Proposed Turkey Point Units 6 and 7  
Docket Nos. 52-040 and 52-041  
FPL Revised Response to NRC RAI No. 02.05.02-3 (eRAI 5896)  
L-2013-305 Attachment 2 Enclosure A Page 1 of 3

**NRC RAI Letter No. PTN-RAI-LTR-037**

**SRP Section: 02.05.02 - Vibratory Ground Motion**

**NRC RAI Number: 02.05.02-4 (eRAI 5896)**

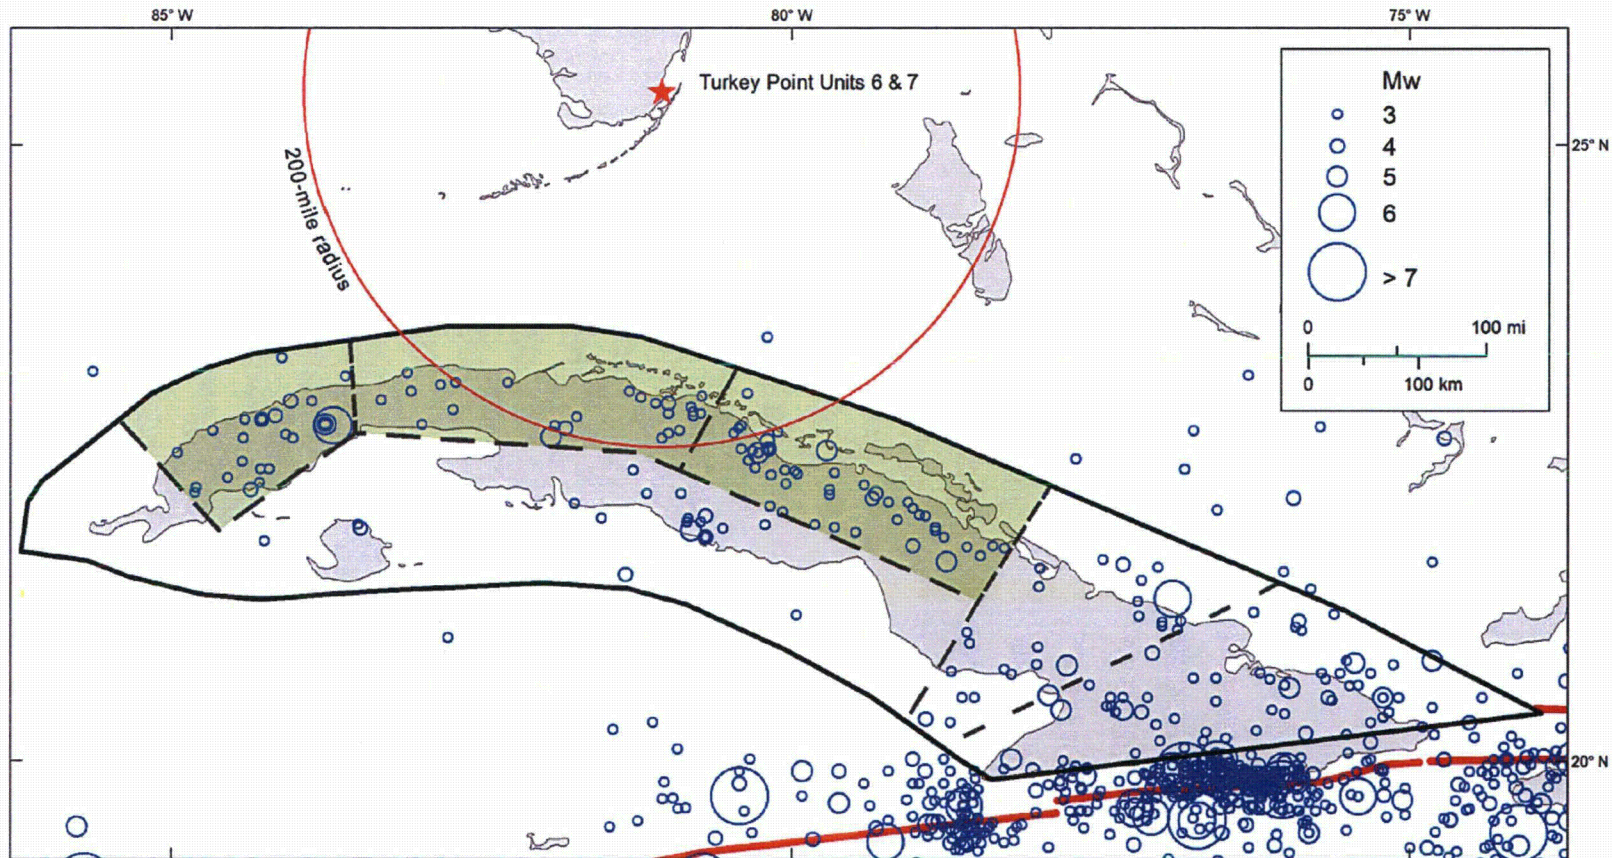
- c. A description of how well the seismic source model parameters represent the observed spatial patterns and concentrations of seismicity. Is a uniform seismic source zone justified considering FSAR Figure 2.5.1-267, which shows prominent clusters of seismicity? Discuss evidence, if any, that frequency-magnitude behavior is different for the subset of earthquakes concentrated in western and northern Cuba than for the entire zone.

- Six areal source zones scenario (Z6): In the six areal source zones scenario, Cuba is divided into six zones largely on the basis of observed patterns in seismicity (Figure 1). The seismicity *b*-value is constant across all six zones and equivalent to that used in the Z1 scenario; the seismicity *a*-values vary from zone to zone, are uniform within each zone, and are based on the observed seismicity within each zone. The Z6 scenario results in the lowest contribution to hazard from the three zone scenarios (Table 1).

- In the characterization adopted for the FSAR, seismicity in Cuba appears to be dramatically higher than in the Straits of Florida (Figure 1) and this difference is not easily attributable to differences in detection capability. For example, the June 2, 1990  $M_w$  3.3 (from the Phase 2 catalog) or  $M_w$  4.09 (from the Phase 1 catalog) earthquake lies just north of the island of Cuba and southwest of the Bahamas, and originated from the Cuba source catalog (Alvarez et al. 1999) (FSAR 2.5.2 Reference 205), which is one of the source catalogs used to develop the Phase 1 and Phase 2 earthquake catalogs (FSAR Subsections 2.5.2.1.2 and 2.5.2.1.3). This implies some detection capability to this magnitude level and distance north of the island, from the Cuba source catalog at least, for the past 20 years. This is in agreement with estimates of detection capability as a function of magnitude for the "Near Florida" area (including the Straits of Florida between southern Florida and the Cuba area) as tabulated in Table 2.5.2-206 of the FSAR.

**Figure 2.** Map of intraplate Cuba fault sources as modeled for hazard sensitivity calculations

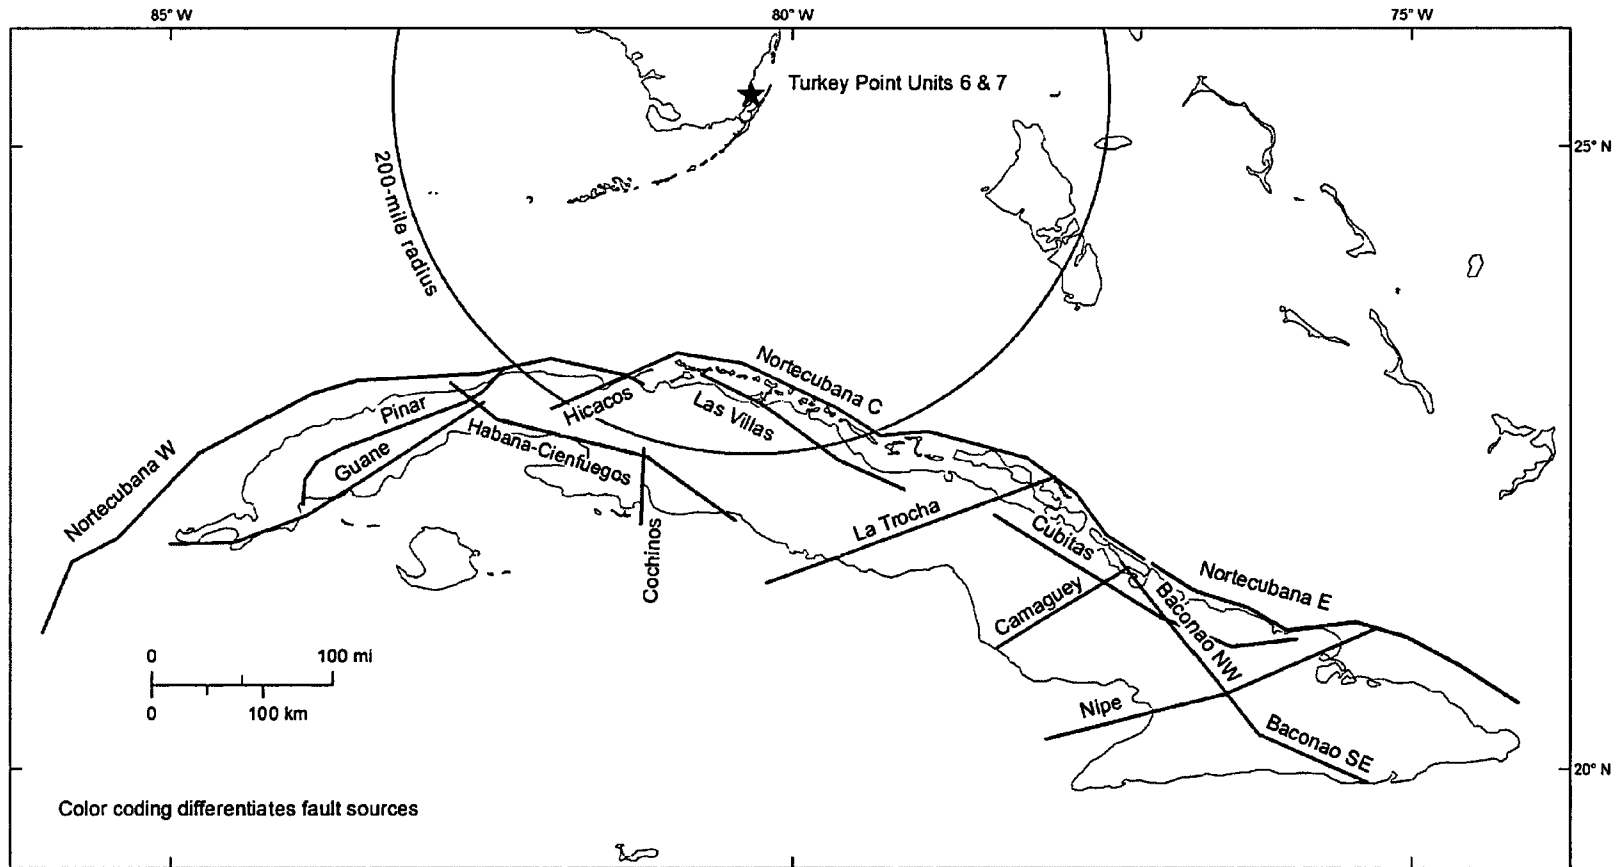
- a. Rationale for the exclusive use of an areal source rather than multiple areal sources or a combination of fault sources and areal sources. Given the uncertainties, does the use of a single areal source result in a more conservative representation of the hazard from the Cuba seismic sources?

To evaluate the potential influence on seismic hazard from the poorly known faults in Cuba, a SSHAC Level 2 study was used to develop a fault characterization model, as described in the response to RAI 02.05.01-21. From this process, 15 fault sources (Figure 2) and a weighted range of fault characterization parameters (Table 3 in response to RAI 02.05.01-21) were developed for the FF scenario in hazard sensitivity calculations. This characterization includes for each fault source three slip rate options, in which the high, middle, and low values on slip rate correspond to three orders of magnitude, reflecting the considerable uncertainty in the available data.

Figure 1. Comparison of converted magnitudes for the complete modified Phase 2 catalog: FSAR vs. CEUS SSC (EPRI et al., 2012). This figure represents the  $M_w$  correlation among 10,747 events.

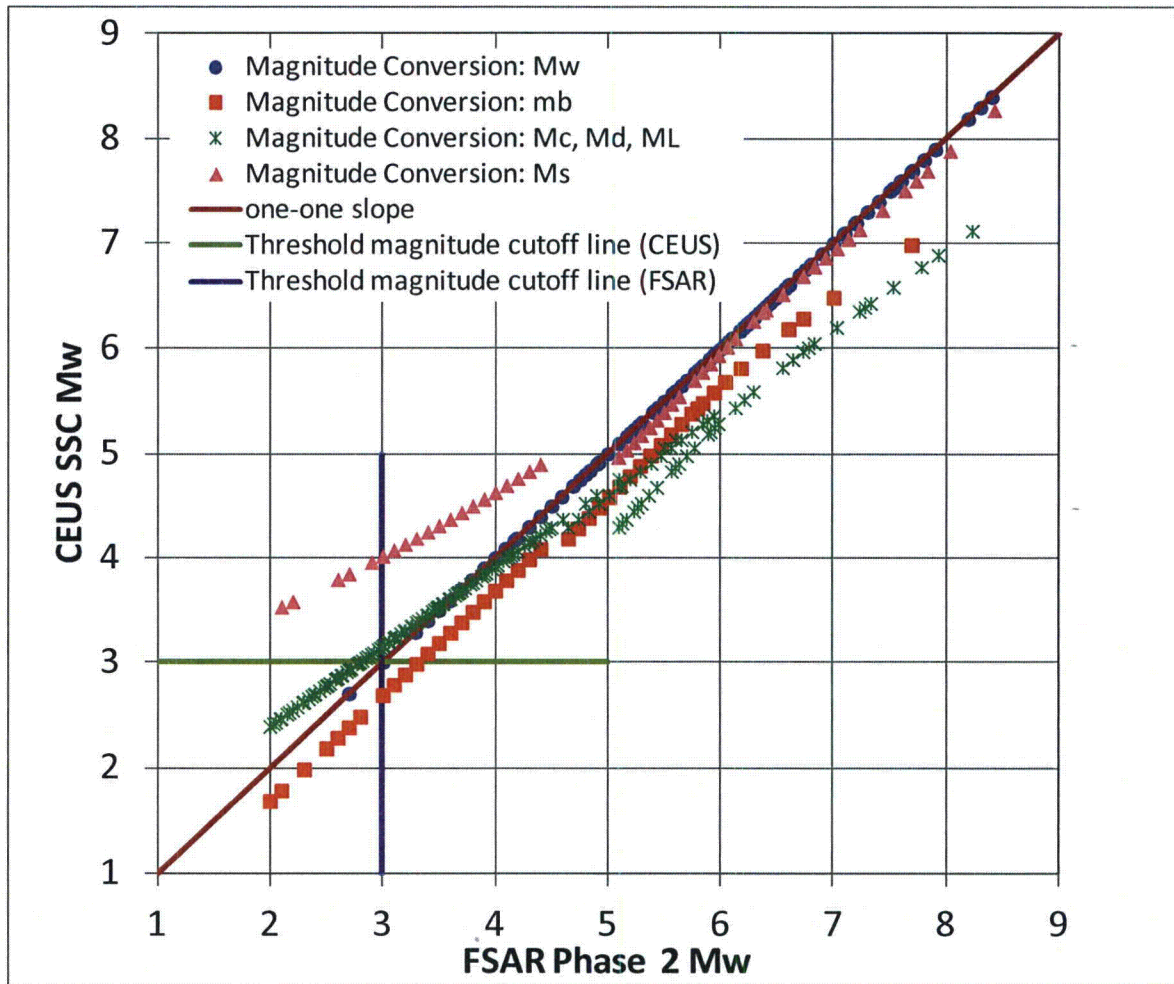
FSAR Subsection 2.5.2.1.3.1 states that  $M_w$  was used as the uniform magnitude measure in Phase II (Caribbean region) earthquake catalog development efforts. Phase I earthquake catalog (EPRI updates), on the other hand, uses  $m_b$  as the uniform magnitude measure. In accordance with NUREG-0800, Standard Review Plan, Chapter 2.5.2, "Vibratory Ground Motion," and Regulatory Guide (RG)1.208, "A Performance-Based Approach to Define the Site-Specific Earthquake Ground Motion", please explain the rationale for selecting  $M_w$  as the uniform magnitude measure for the Caribbean earthquake catalog rather than  $m_b$ . Discuss what impact, if any, this choice had on the number of earthquakes listed in the Caribbean earthquake catalog. Were there any earthquakes with  $m_b$  of 3.0 (or perhaps larger) that did not make the  $M_w \geq 3.0$  cut used in Phase II catalog development?

leads to a smaller estimate of moment magnitude than considered in the FSAR – see Figure 1. For example, if the CEUS-SSC magnitude conversion relations had been considered for the Phase 2 catalog, the moment magnitude equivalent to  $m_b$  3.0 would be about  $M_w$  2.7, instead of the  $M_w$  3.0 in the FSAR.

Figure 1 indicates that for about M<sub>w</sub> 3.5 and greater, the CEUS SSC leads to smaller converted M<sub>w</sub> magnitudes, notably so for the largest magnitudes. For M<sub>w</sub> less than about 3.5 the CEUS SSC magnitude conversions lead to slightly larger M<sub>w</sub> magnitudes. Further, considering the intent of presenting the Phase 2 catalog as M<sub>w</sub> 3.0 and greater, the CEUS SSC magnitude conversions would add some additional events which the FSAR catalog would have considered M<sub>w</sub> 2.8 to 3.0.

leads to very similar estimates of moment magnitude for earthquakes larger than 4.5 as those that were considered in the FSAR (FSAR 2.5.2) – see Figure 1. For the relatively few events with M<sub>s</sub> less than 4.5 in the Phase 2 catalog, the CEUS SSC magnitude conversion leads to larger M<sub>w</sub> magnitudes than the conversion assumption of equivalence in the FSAR.

**Figure 1. Seismic Sources from the U.S. Geological Survey's 2008 National Seismic Hazard Mapping Project  
(Petersen et al. 2008 FSAR Reference 300)**

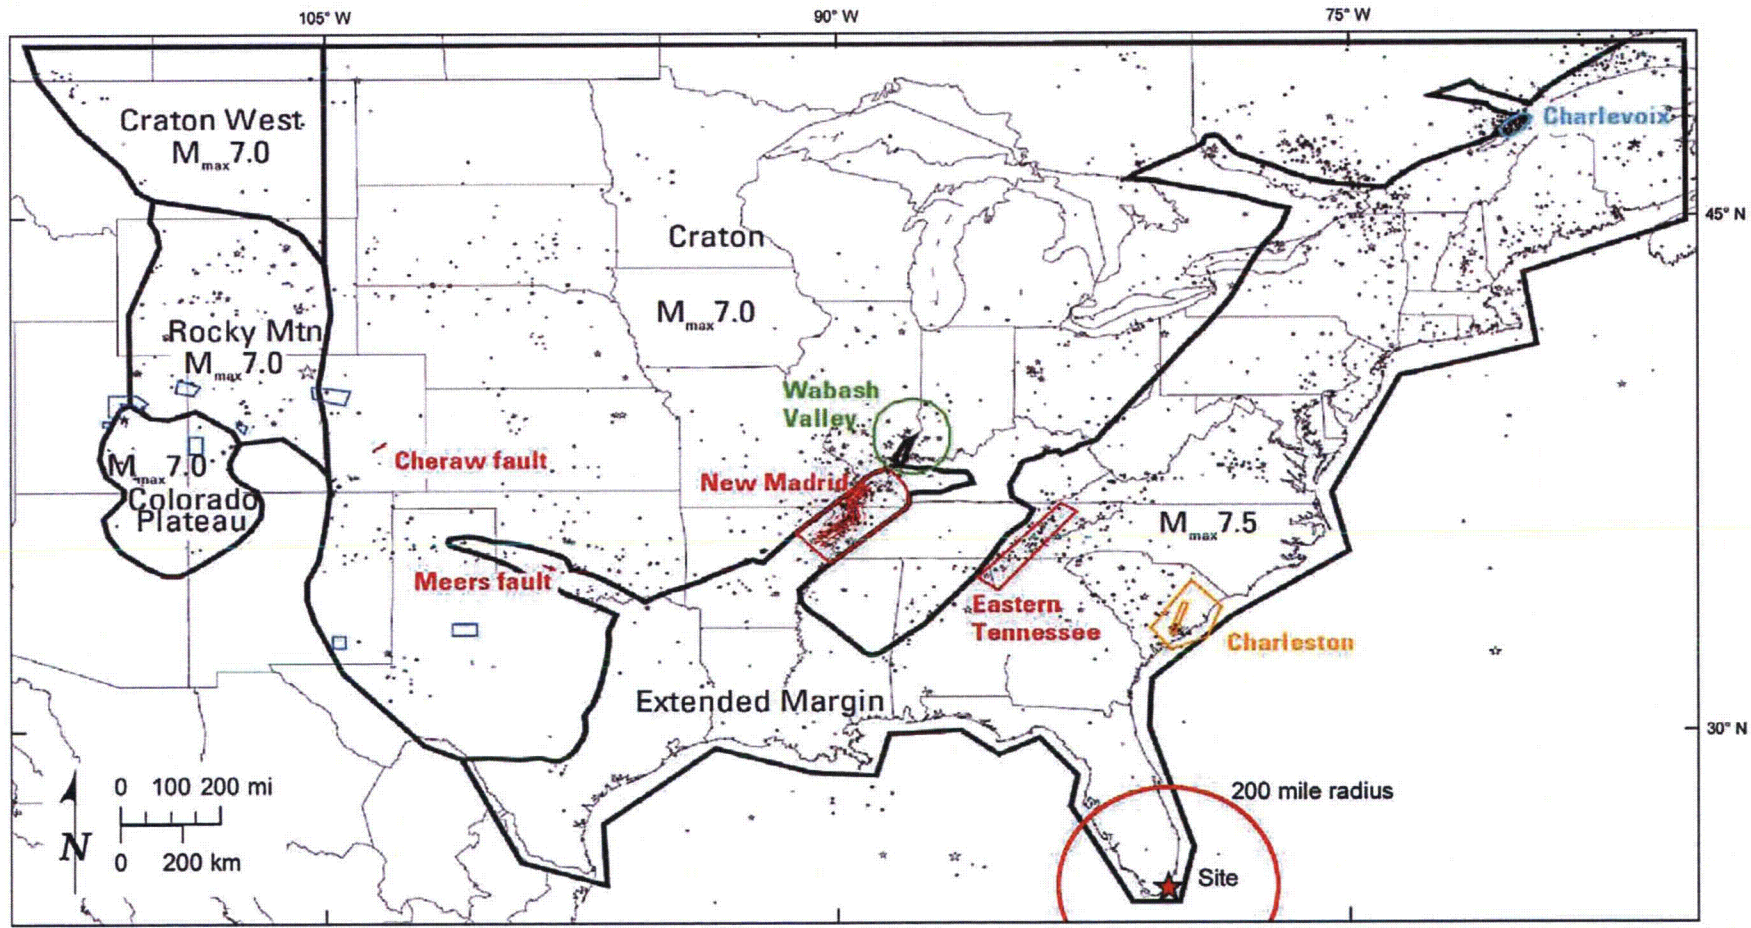
The FSAR does not list the USGS national seismic hazard map project as a potential source for EPRI seismic source model updates. The USGS regularly updates its own national seismic hazard maps using the most recent data and information. Within the last decade, the USGS published two comprehensive national seismic hazard reports in 2002 and 2008. RG 1.208 indicates that existing seismic source models should be evaluated in light of more recent data and evolving knowledge. Please discuss why the USGS national seismic hazard maps and model parameters are not discussed as potential studies to be considered in updating the existing EPRI seismic source geometries and/or model parameters.

The 2008 NSHMP earthquake sources are depicted in Figure 1. Significant changes from the 2002 NSHMP (FSAR Reference 251) model of seismic hazard in the CEUS include: (1) uncertainty in the maximum magnitude ( $M_{max}$ ) assigned to  $M_{max}$  zones (e.g., Extended Margin); (2) revised geometry of the Charleston seismic source zones; and (3) revised magnitudes, rates, and geometry for the New Madrid seismic source. As a result of these updates, the 2008 NSHMP characterizes  $M_{max}$  for the Extended Margin and Craton as weighted distributions ranging between  $M7.1 - 7.7$  and  $M6.6 - 7.2$ , respectively. The two areal zones defining the Charleston source are both assigned  $M_{max}$  distributions of  $M6.8 - 7.5$  with a recurrence interval of 550 years, unchanged from the 2002 NSHMP (FSAR Reference 251). The Charleston seismic source updates from the NSHMP (FSAR Reference 300) are discussed in Subsections 2.5.2.4.4.2.2 and 2.5.2.4.4.2.3.

The NSHMP model only covers a small portion of the site region (Figure 1) and does not include seismically active areas in the southern part of the site region and beyond, such as Cuba and the North America-Caribbean plate boundary that contribute to the seismic hazard in southern Florida. Therefore, a direct comparison between the NSHMP SSC model and the FSAR SSC model is not presented in the FSAR.
